## **COUNCIL SUBMISSION – Parramatta Light Rail Stage 2 EIS, public consultation**

### **EXECUTIVE SUMMARY**

Figure 1 Base case alignment along Grand Avenue (bold line) with foreshore bridge crossing (dashed line)

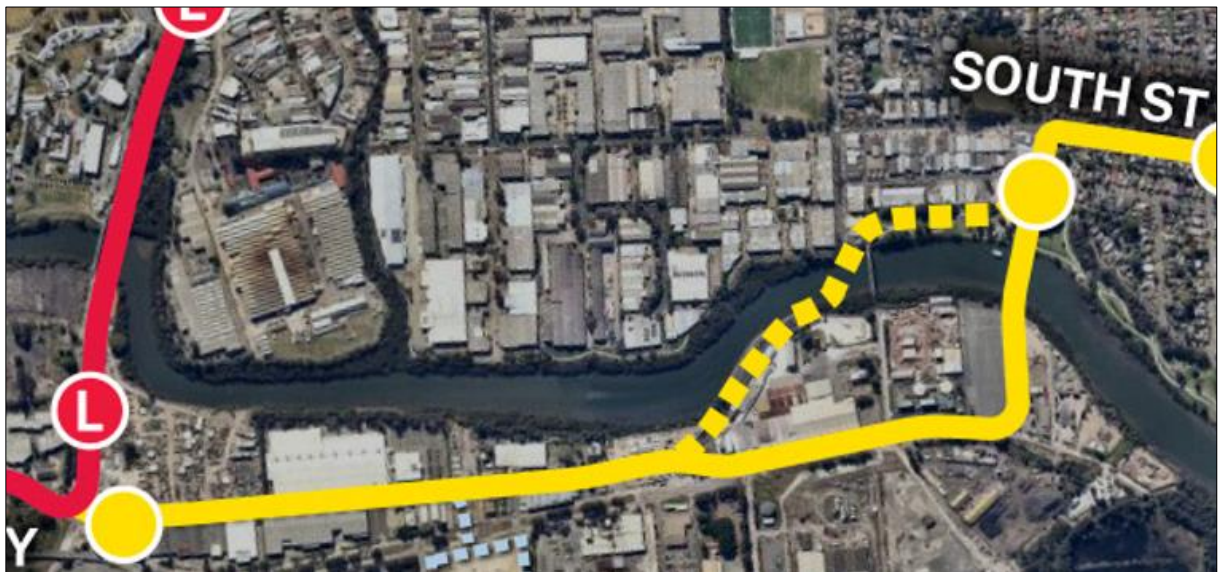
Council's stated preference is for the base case Camellia option – Figure 1 below, however the alternate 'A9' Camellia to Rydalmere foreshore alignment at Figure 2 would be supported by Council only if it ran immediately south of Antoine Street and not through the foreshore park. Foreshore open space is a difficult to replace precious community asset and TfNSW should take a long term view of the light rail asset and alignment. Loss of open space is long term, acquisition impacts may have a shorter term.

In relation to the option, the EIS does not adequately discuss the visual impact of the embankment based alignment through the foreshore park, including loss of the existing tree scape shielding industrial buildings from the park. Instead the EIS conflates that impact with a positive impact of rail passengers and visitors having a more scenic journey over the river bridge and along the Camellia foreshore.

Council maintains its objection to the loss of foreshore land, which due to the creation of embankments for flood immunity and loss of screening trees, will result in the tracks and catenary wires being visually intrusive, with a reduction in the remaining foreshore parkland to transit corridor associated minor green space.

**Recommendation 3 – TfNSW to remove the light rail alignment from Eric Primrose Reserve.**

Figure 4 Proposed green track areas

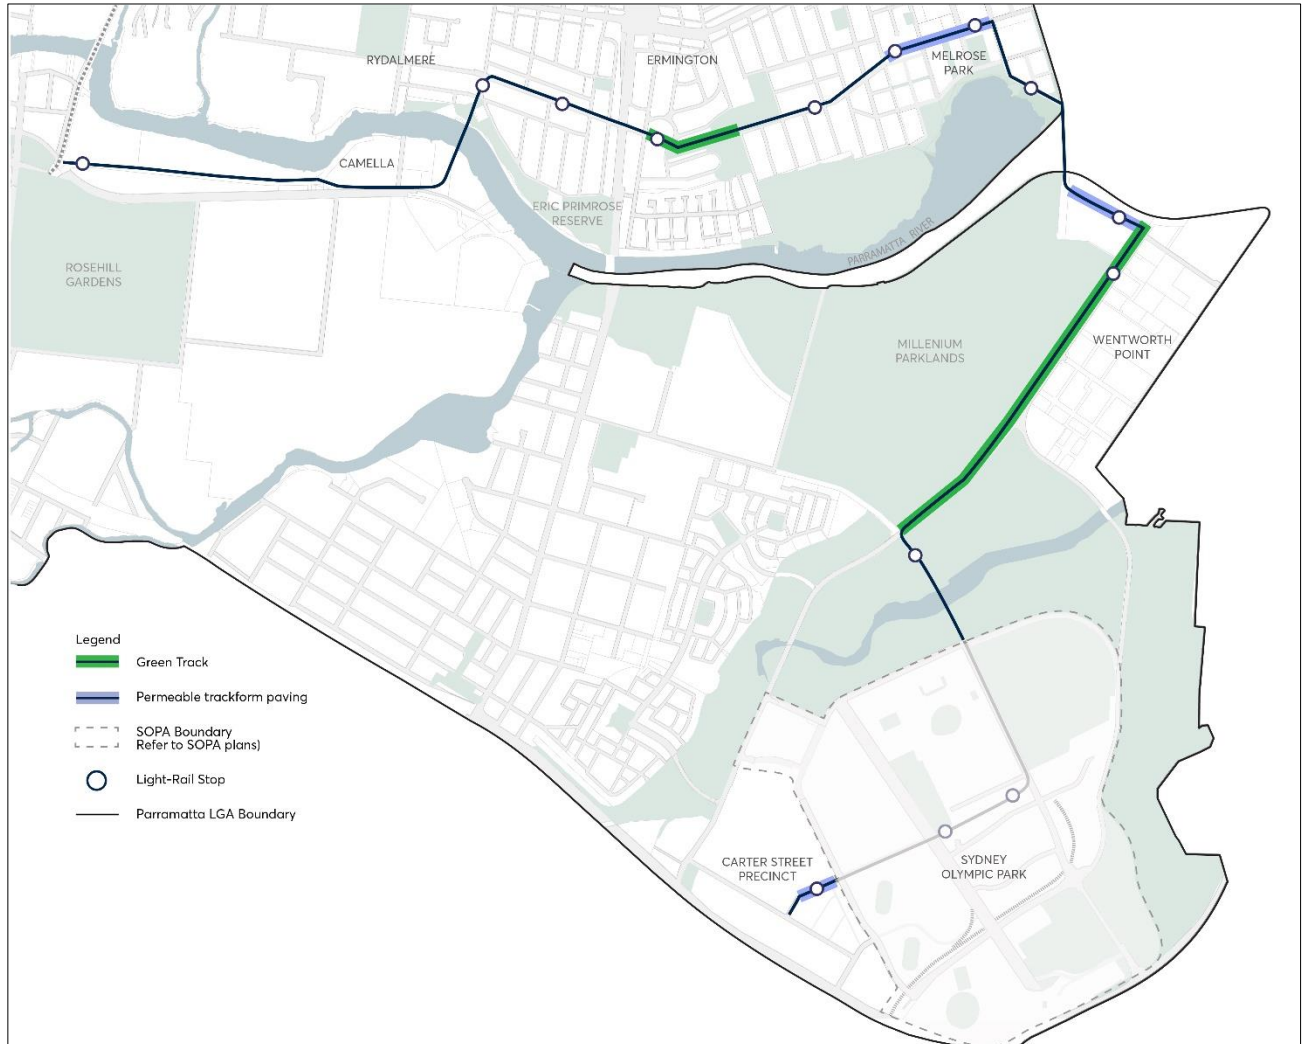
Figure 4 indicates where green track areas should be provided along the alignment, namely the green space between South Street and Boronia Street, Ken Newman Park and the long Hill End Road hardstand strip. Figure 4 also indicates where permeable track form paving could be provided, for a softer public domain finish.

**Recommendation 6 - Council recommend to TfNSW the provision of green track and permeable paving per Figure 4.**

Figure 5 Proposed wire free running area

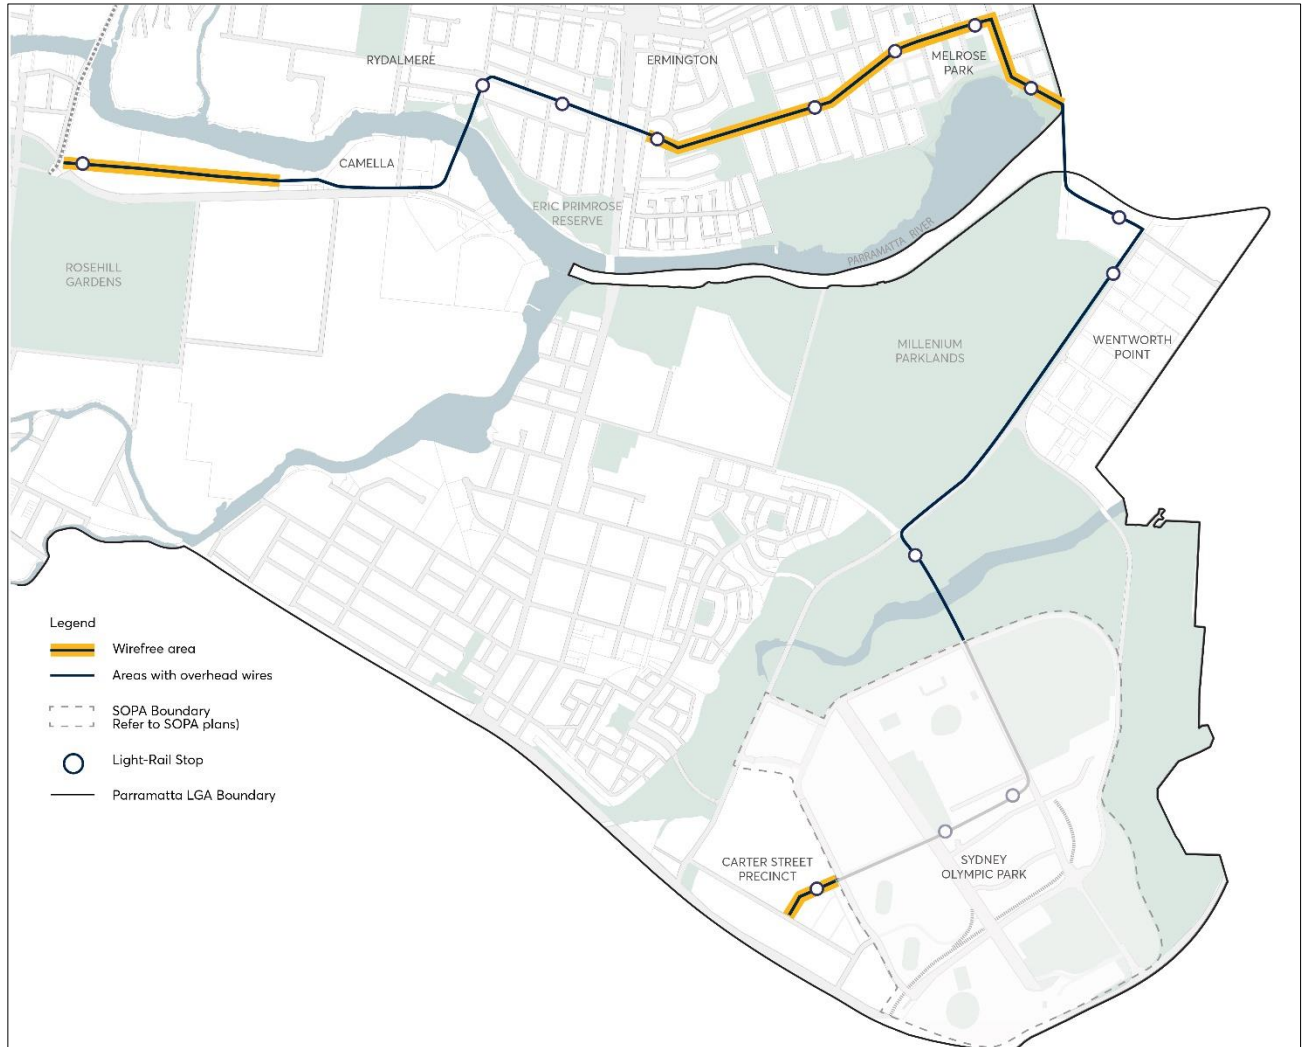
Wire free (catenary free) areas can considerably improve the visual impact of the Project by limiting most infrastructure to track level only. Figure 8 indicates that wire free running should be provided in the future Camellia town centre, the residential green space east of South Street, through Melrose Park, and through to the River, along with the Carter Street precinct in Sydney Olympic Park.

Wire-free running should be provided in high density residential areas, and specifically within the Ken Newman Park reserve and adjoining linear green space, to improve the amenity of those residents who will now have a train line running behind them, replacing existing lightly used green space.

**Recommendation 7 - Wire-free running should be provided in high density residential areas, and specifically within the Ken Newman Park reserve and adjoining linear green space.**

Figure 8 Boronia Street looking east – light rail alignment

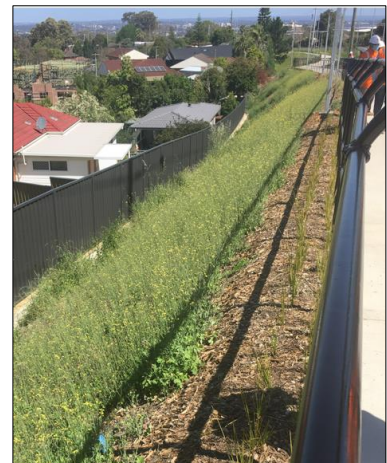
The Stage 2 alignment is heavily undulating and quite complex in terms of existing gas and water pipelines. Considerable cut and fill will be required to ensure maximum alignment gradients are not exceeded. Figures 6-8 below provide examples of this complexity, where site cut will be required.

Cut and fill requirements should not compromise the public areas - the new light rail alignment must be a good neighbour to adjoining residential and business properties and the alignment should not isolate the community it serves.

Road and other areas of the alignment with significant cut should aim to maximise safe and convenient cross-connections for pedestrians, cyclists and persons with a disability (maximum distance of 200m-400m between cross-connections).

**Recommendation 8 – The Department apply a condition of planning approval requiring TfNSW to investigate and provide north/south pedestrian crossing points over the alignment every 400m or otherwise to match existing connections, particularly where signalised intersections are not available and/or the alignment is cut into the existing road way.**

Figure 10 Narrow, linear utility corridor and green space between South Street & Boronia Street

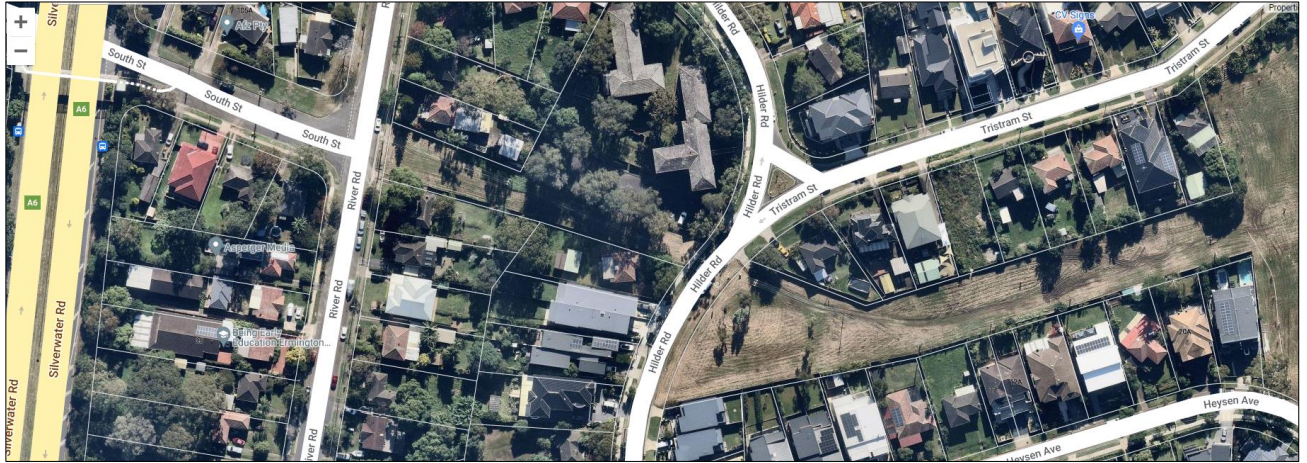
PLR Stage 2 runs through approximately 2km of low density residential streets, including some 400m of linear green space behind houses and through Ken Newman Park (see Figure 10) and approximately 2km of existing high density residential - not including any future high density residential at Camellia. The built environment context is quite different to Stage 1, which is primarily commercial development and an existing heavy rail corridor.

Creating a new light rail line through existing residential roads and green space will require design led solutions and the best possible noise and vibration mitigation and visual amenity measures. This includes:
